**Proposal for inclusion of additions
to ATA/ATAPI-4 required to specify
an 80-conductor cable assembly
and a 40-conductor cable assembly
with an alternate CSEL configuration**

To: T13 Technical committee
From: Mark Evans
Quantum Corporation
500 McCarthy Boulevard
Milpitas, CA USA 95035
Phone: 408-894-4019
Fax: 408-894-4990
Email: mevans@qntm.com
Date: 21 May 1997
Subj: Proposal for inclusion of additions to ATA/ATAPI-4 required to specify an 80-conductor cable assembly

Figure x1 – PDIAG- example using an 80-conductor cable assembly

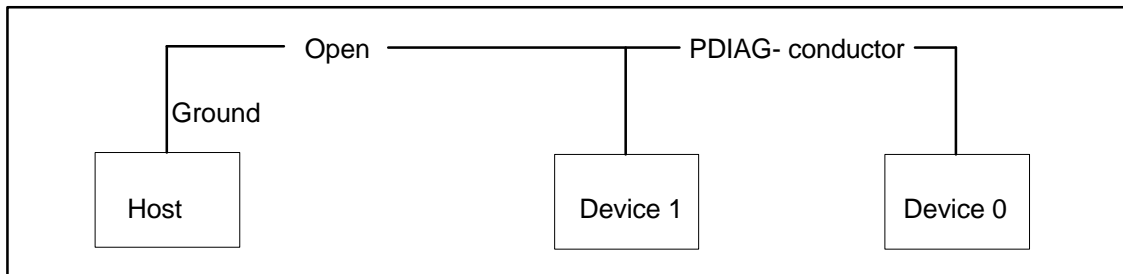
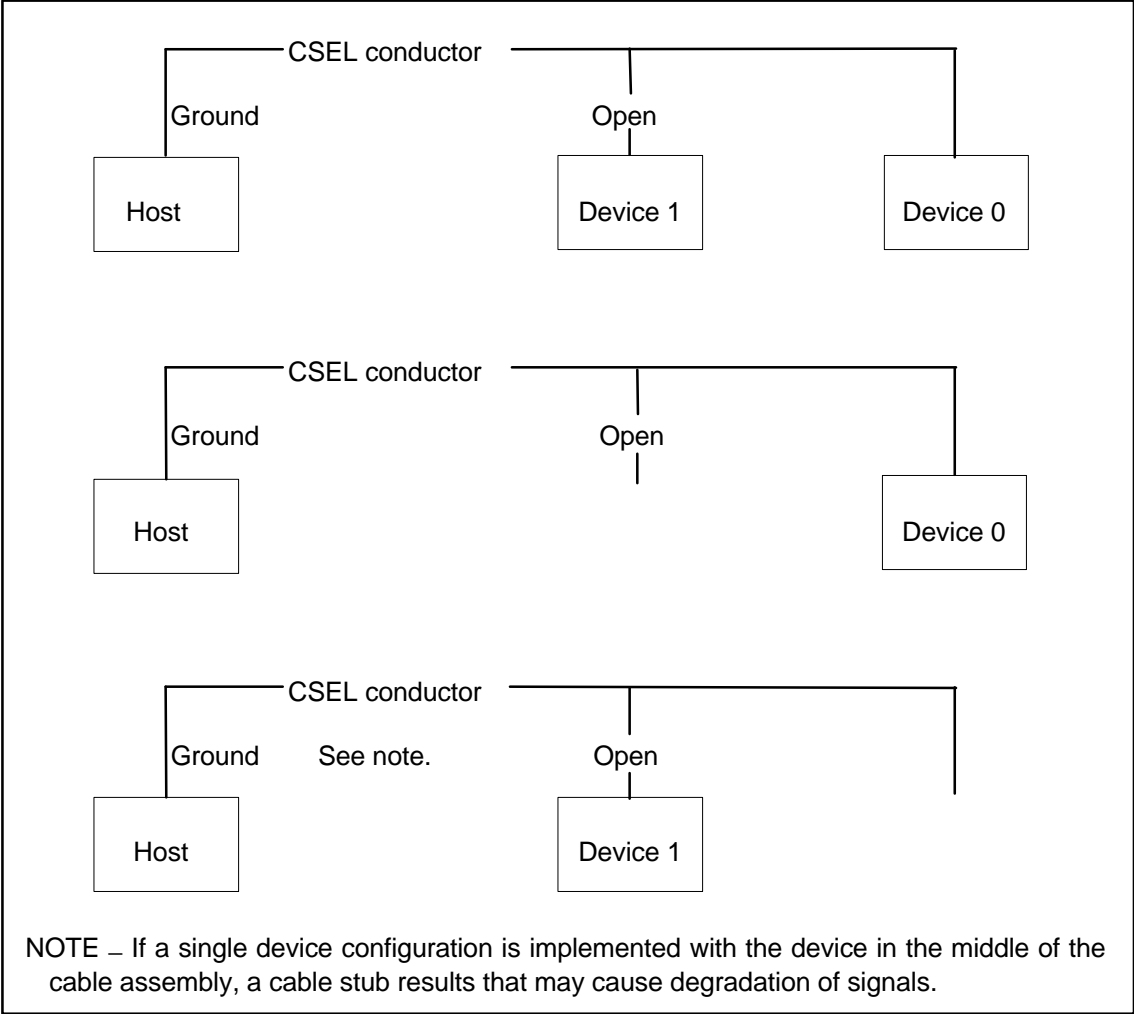
5.2.11 PDIAG-/~~CBLID~~- (Passed diagnostics/~~Cable assembly type identifier~~)

The host may sample this signal after the completion of each hardware reset sequence in order to detect the presence or absence of an 80-conductor assembly. If the host detects that the signal is connected to ground, then an 80-conductor assembly is installed in the system. If the host detects that the signal is not connected to ground, then an 80-conductor assembly is not installed in the system.
